**Revision to a Request for a Standing Offer**

<b>Title - Sujet</b> Office Furniture-Meubles - Carling		
<b>Solicitation No. - N° de l'invitation</b> EP837-161021/A		<b>Date</b> 2015-11-06
<b>Client Reference No. - N° de référence du client</b> 20161021		<b>Amendment No. - N° modif.</b> 001
<b>File No. - N° de dossier</b> pq956.EP837-161021	<b>CCC No./N° CCC - FMS No./N° VME</b>	
<b>GETS Reference No. - N° de référence de SEAG</b> PW-\$\$PQ-956-68135		
<b>Date of Original Request for Standing Offer</b>		2015-10-08
<b>Date de la demande de l'offre à commandes originale</b>		
<b>Solicitation Closes - L'invitation prend fin at - à 02:00 PM on - le 2015-11-20</b>		<b>Time Zone Fuseau horaire</b> Eastern Standard Time EST
<b>Address Enquiries to: - Adresser toutes questions à:</b> Goyette, J-F		<b>Buyer Id - Id de l'acheteur</b> pq956
<b>Telephone No. - N° de téléphone</b> (613) 219-0728 ( )	<b>FAX No. - N° de FAX</b> (819) 956-5706	
<b>Delivery Required - Livraison exigée</b>

## Tender Questions #1

Workstation RISO

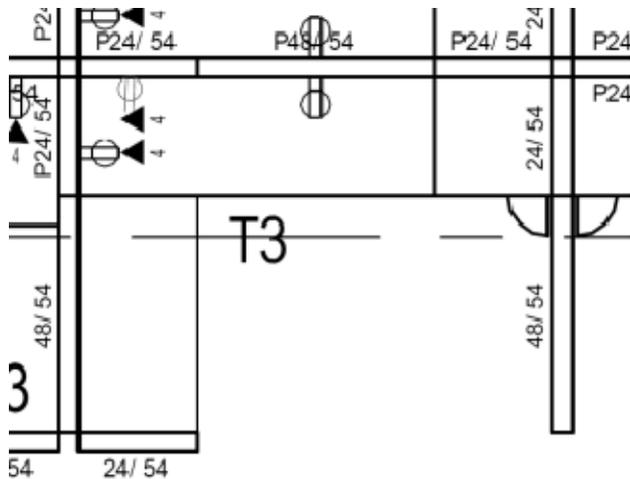
- Q2. Annex A-1 section 8.2.2.3 requires the use of three (3) duplex receptacles. Can we provide three (3) triplex receptacles, which meets and exceeds the requirements?
- A2. **No, the Government of Canada Workplace 2.0 Fit-Up Standards specifies three (3) duplex receptacles, the use of three (3) triplex receptacles is above the standards and thus considered non-compliant.**
- Q3. Annex A-3 indicates 2 outlets on the 24" wide panels. Our 24" wide panels can accommodate one outlet. We could relocate one of these outlets to the adjoining 24" wide panel and still meet functional requirements. (see sketch) Please confirm this is acceptable.

- A3. **Location of the one (1) duplex receptacle on each of the 24" wide panels will be accepted as long as all other requirements are met.**
- Q4. Annex A 10.1 requests that free-standing HA work surfaces must have crank, torsion or counter-balance height adjustment mechanism. These options are often times the same price as an electric adjustable unit and are less functional due to adjustment requirements and weight restrictions. Please confirm that an electric adjustable option would be acceptable.
